COUNCIL AGENDA STATEMENT

Agenda Item: **Resolution 2026-42** Approving Change Order #4 Either Option 1 In The Amount Of \$57,038.16 Or Option 2 In The Amount Of \$266,225.88 For The Marathon Sombrero Blvd Drainage Improvements Project; Authorizing The City Manager To Sign The Work Directive Change And To Expend Budgeted Funds; And Providing An Effective Date.

Memorandum

Date: April 30, 2026
To: Steve Williams – Interim City Manager, City of Marathon
From: Steve Suggs, P.E. – Principal Engineer, Apex Companies LLC
CC: Dan Saus – Utilities Director, City of Marathon ; Jared Weaver – Utilities Field Engineer, City of Marathon
Regarding: Sombrero Blvd Drainage Improvements – Change Order #4

Figure 1: Snippet of Well Head where Pipe Support is Proposed

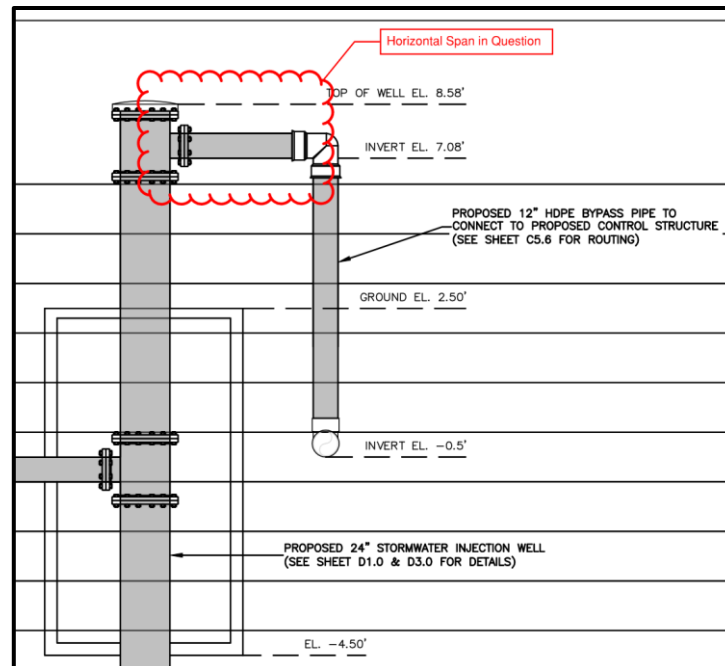
During construction of the pump-assisted injection well system, field conditions required minor adjustments to the location of the injection well to avoid conflicts with an existing vacuum main and an overhead power line. As a result of this shift, modifications to the well lid and associated piping configuration were necessary to accommodate the adjusted alignment of piping entering the structure.

Due to this reconfiguration, the horizontal section of ductile iron bypass piping extending from the well head requires additional structural support to properly manage loading conditions. Without adequate support, the weight of the piping, combined with operational loading from water flowing through the system, could place additional stress on the interconnecting piping and well components, potentially leading to long-term issues such as joint fatigue or leakage. Figure 1 below indicates the section of pipe referenced.

To address this condition, installation of a 12-inch stainless steel pipe support has been proposed. The support will be mounted to the concrete structure and is intended to transfer loading away from the piping and onto a stable structural element, providing a more appropriate and reliable long-term support condition for the bypass piping. Stainless steel is specified for this application due to the project's coastal environment, where corrosion resistance is critical. Use of stainless steel eliminates the need for ongoing recoating or maintenance and provides a durable, long-term solution.

The cost impact associated with this additional scope results in a \$2,940.21 increase to the project cost. Appendix C provides a detailed breakdown of the contractor's PCO for this work.

NAME: THREADED BELL SUPPORT W/ U BOLT

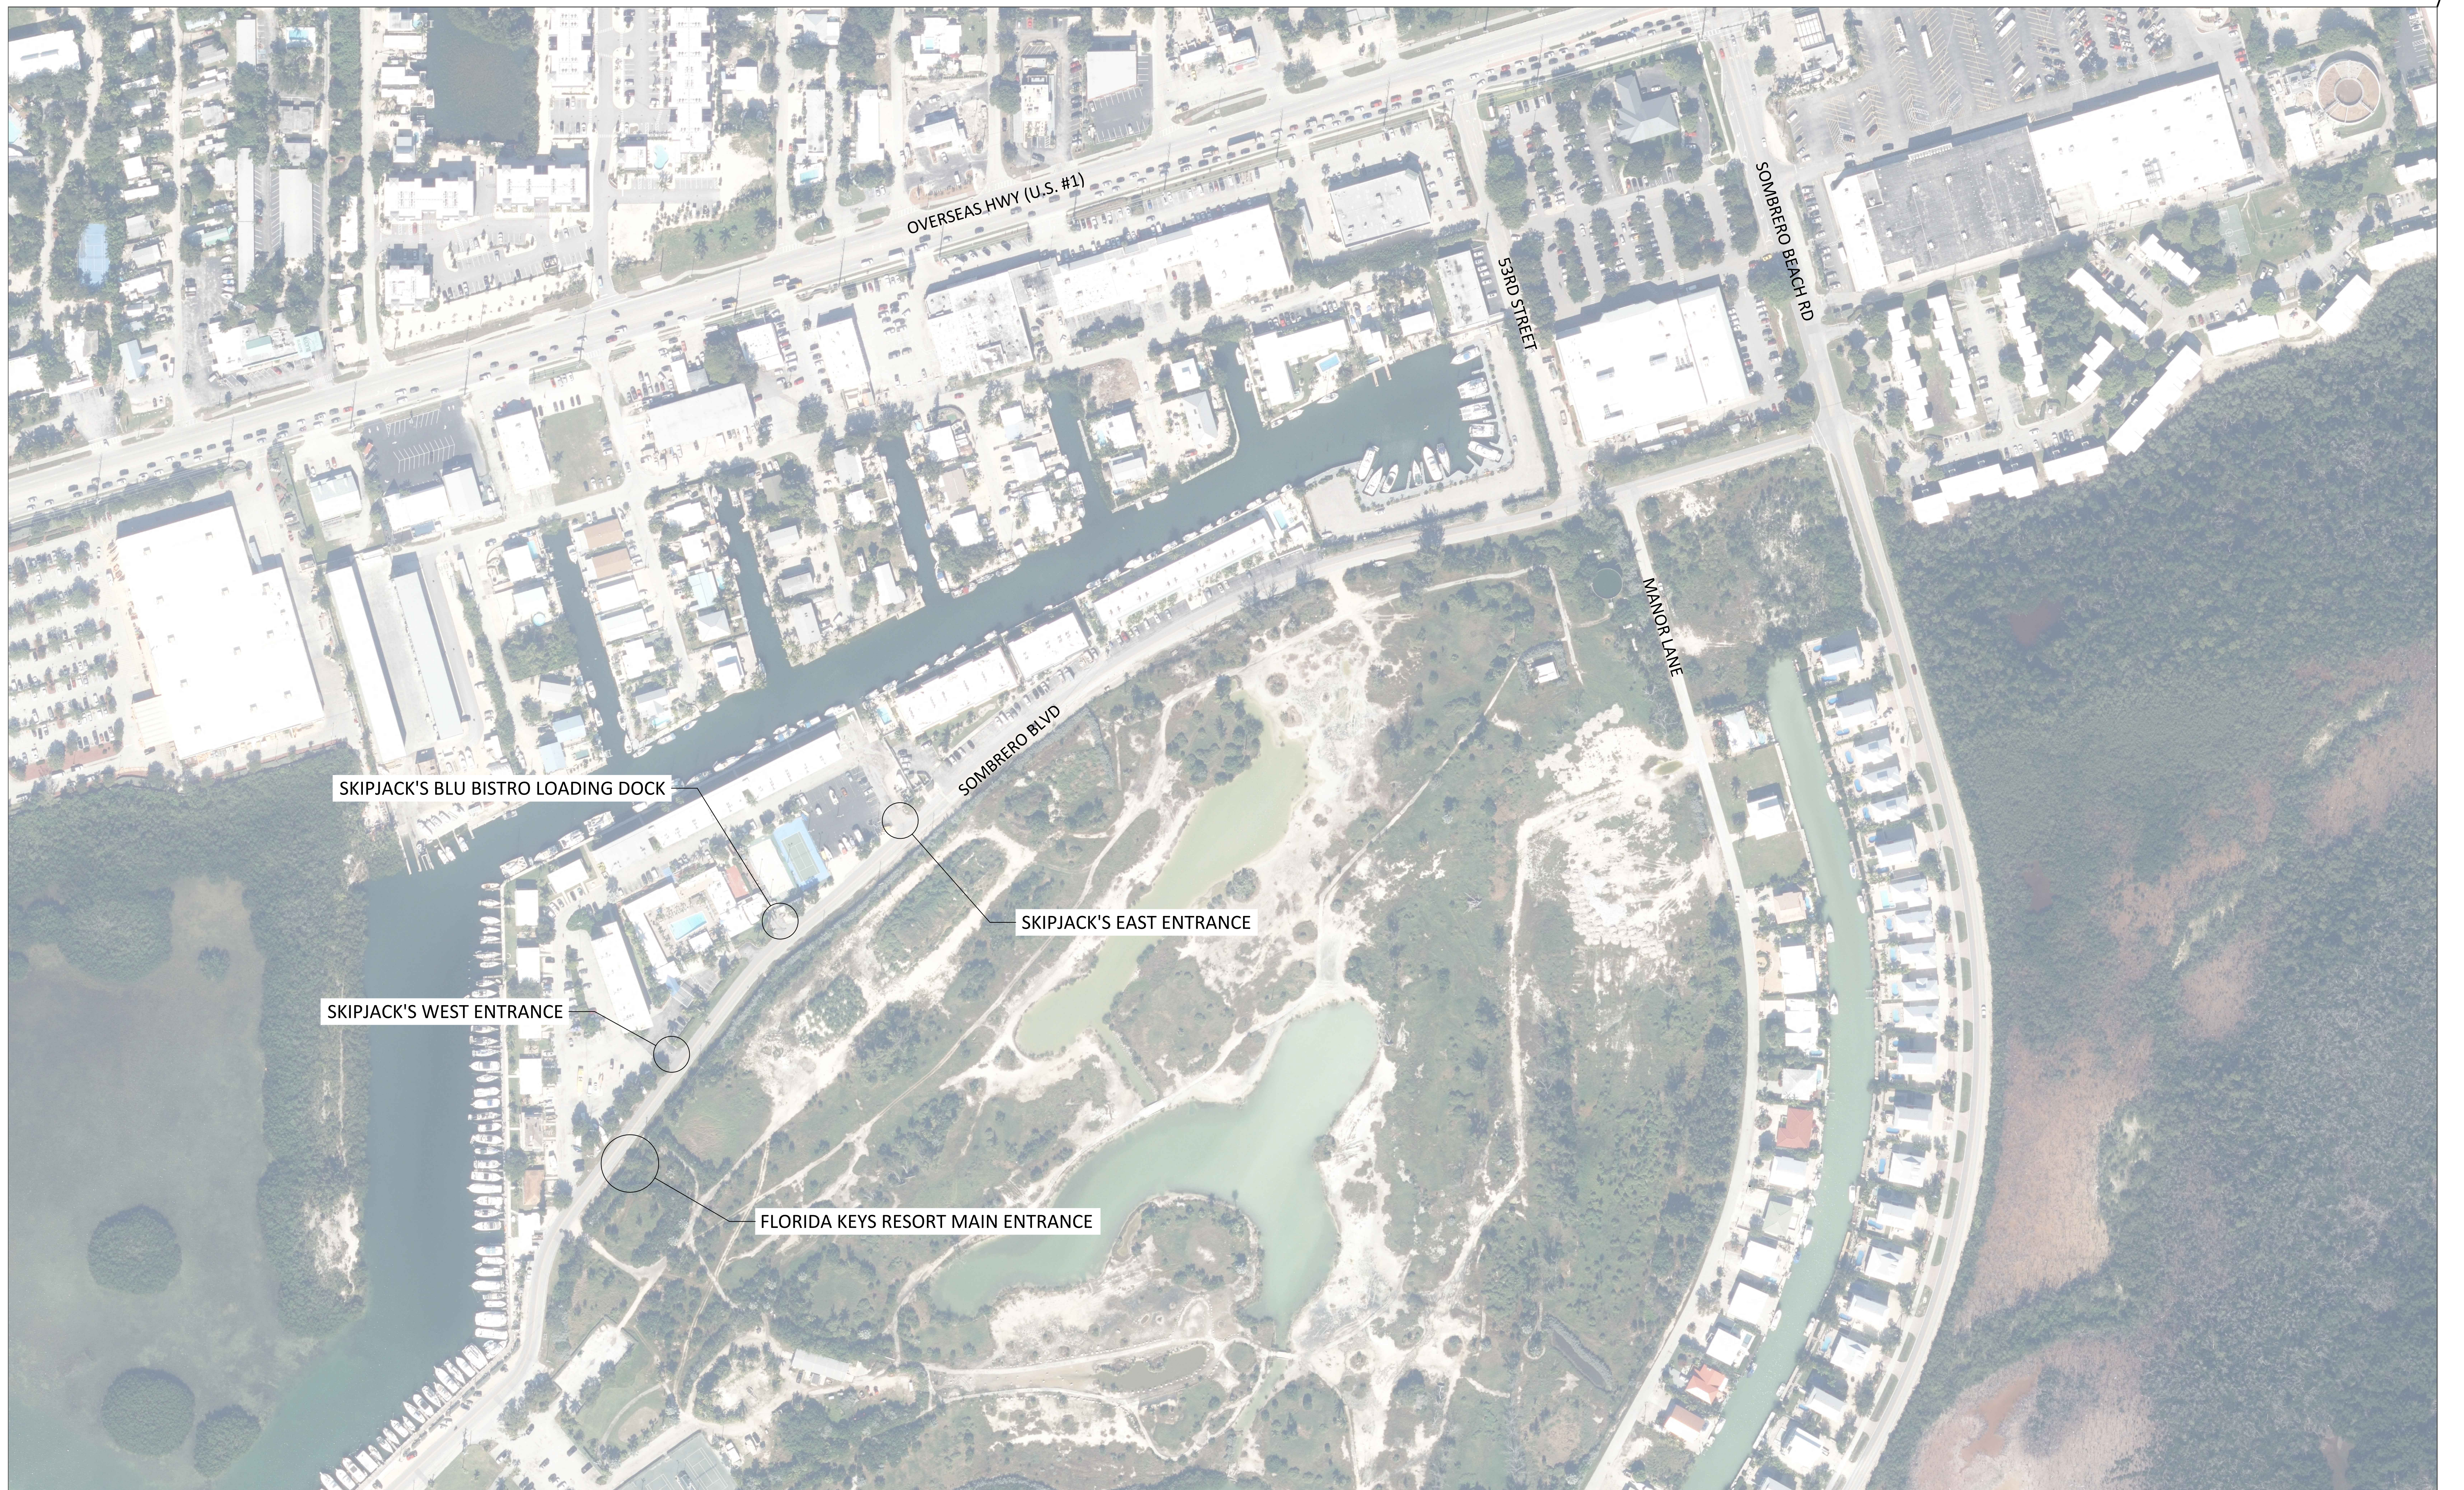
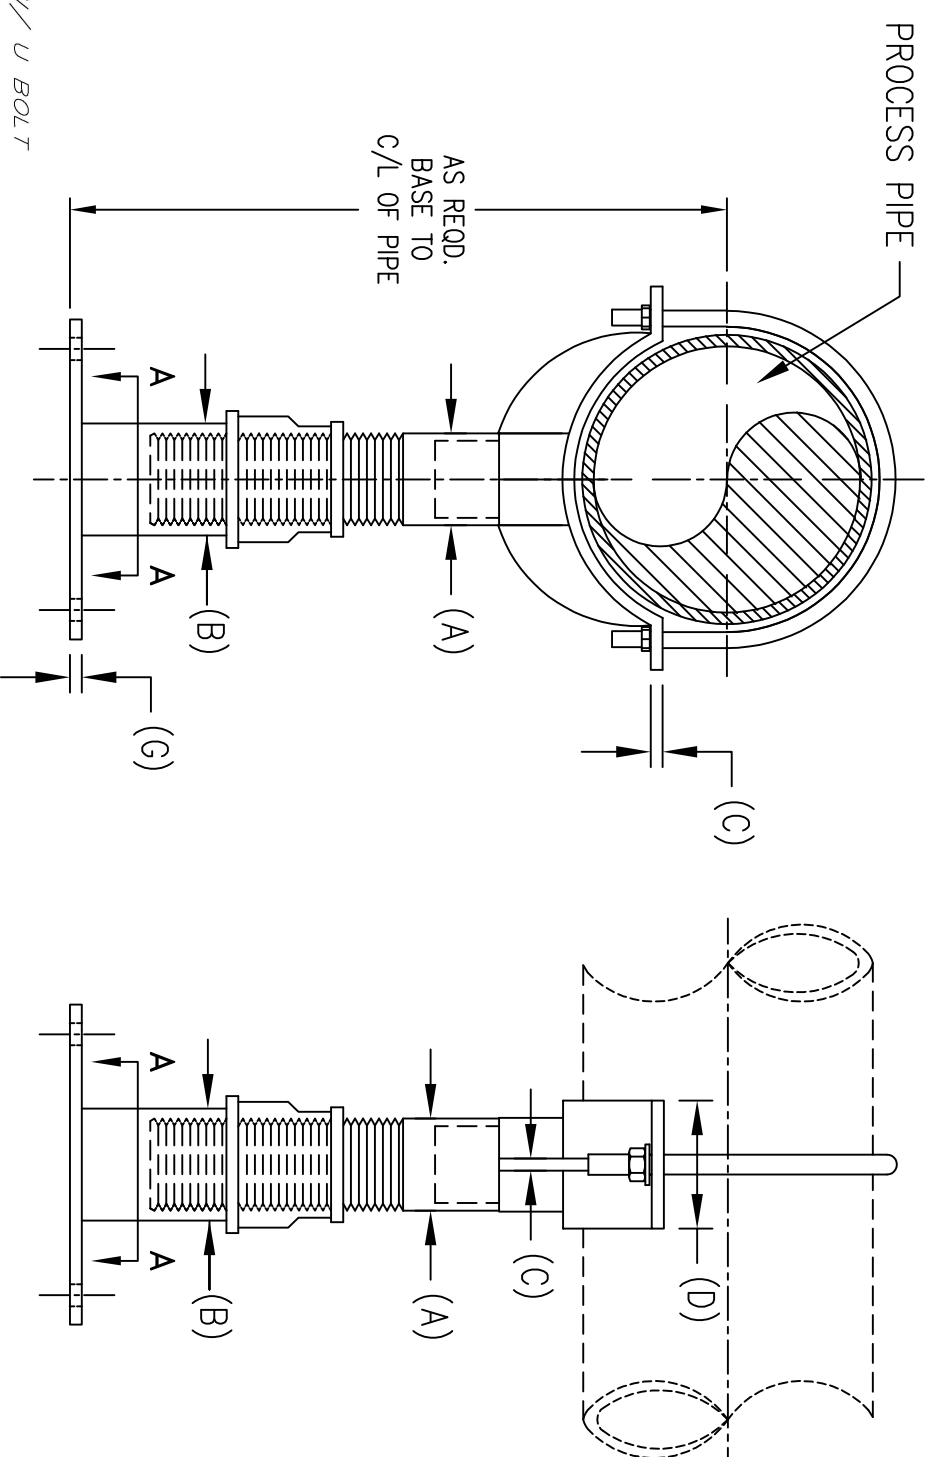
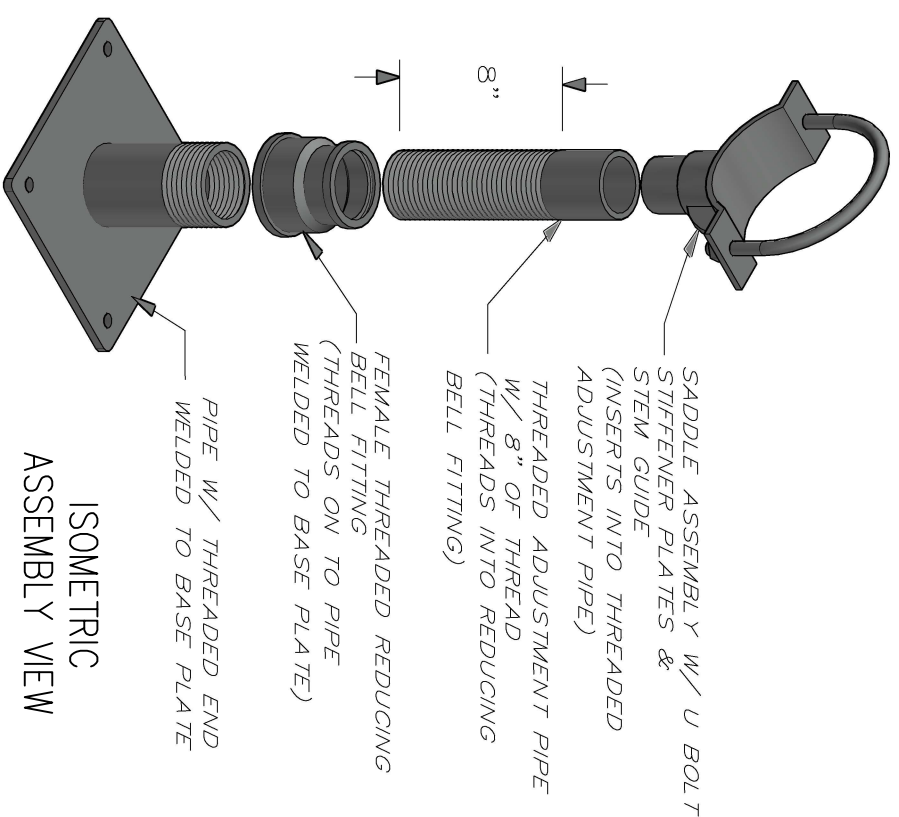
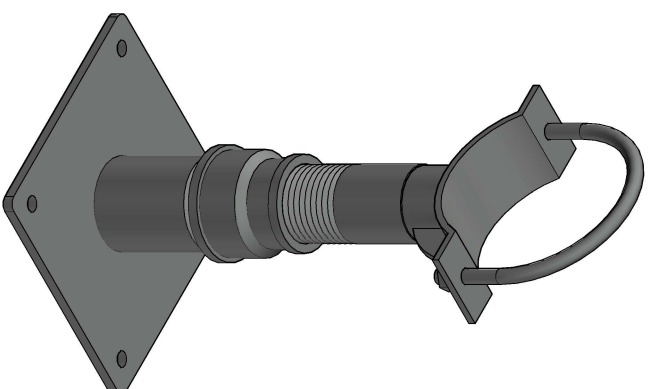
PCO #1 – Stainless Steel Pipe Stand

Item	Description	Quantity	Net Price	UM	Total
SP-12SSSUP	12 SS PIPE SUPPORT T316SS 4'-3" FLOOR TO C/L OF PIPE (+/-) 3" ADJUSTMENT	1	1720.000	EA	1720.00
